ADDENDUM #2 October 23, 2012

SUBJECT: 13-AC REYNOLDS HIGH MINITORIUM WALL PANEL REPLACEMENT (RPF 30-12)

PROVIDE FIRESTOPPING AT NEW CURTAINWALL

AND ADJACENT SLAB EDGE TO PROVIDE 1 HOUR

WALL SECTION

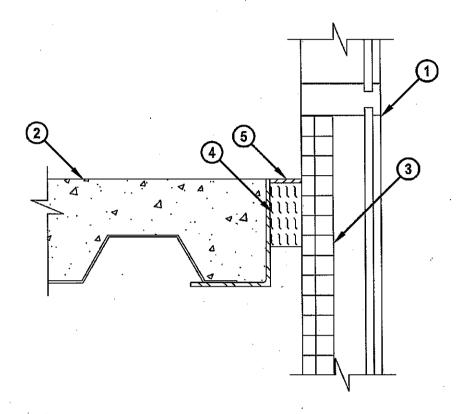
- 1. Clarification: Notes relating to "Hat Channel" or "Z-purlin": Provide 16ga minimum per MBCI engineering, Basis for Design.
- 2. Provide Allowance #1: Per attached drawings, provide firestopping as noted. Allowance amount is \$ 4598.00. Subcontracted work to be provided by Garnet Hill Construction, firestopping specialty contractor. Contact: Ed Caskey, (828) 206-0368 or garnethillinc@aol.com.
- 3. <u>References to Existing wall panel removal in the Documents:</u> Wall panel removal will be completed by Owner. Contractor to coordinate construction schedule with panel removal.
- 4. Firestopping drawings attached.

### **ENGINEERING JUDGMENT FIRESTOP DETAIL**

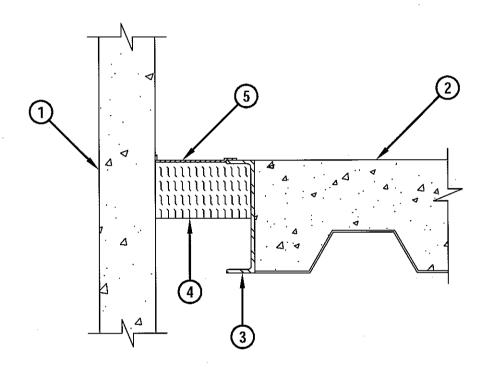
- 1. PRECAST CONCRETE CURTAIN WALL ASSEMBLY (MINIMUM 4" THICK) (NON FIRE-RATED).
- 2. CONCRETE FLOOR OVER METAL DECKING ASSEMBLY (MINIMUM 5" THICK) (1-HR. FIRE-RATING).
- 3. STRUCTURAL STEEL CHANNEL (NON FIRE-RATED).
- 4. MINIMUM 4" THICKNESS MINERAL WOOL SAFING (MIN. 4 PCF DENSITY) COMPRESSED 33%, FLUSH WITH TOP SURFACE OF FLOOR ASSEMBLY.
- 5. MINIMUM 1/8" (WET) THICKNESS HILTI CFS-SP WB FIRESTOP JOINT SPRAY TO COMPLETELY COVER MINERAL WOOL, OVERLAPPING MINIMUM 1/2" ONTO CONCRETE FLOOR AND CURTAIN WALL.

NOTES: 1. MAXIMUM WIDTH OF JOINT = 3".
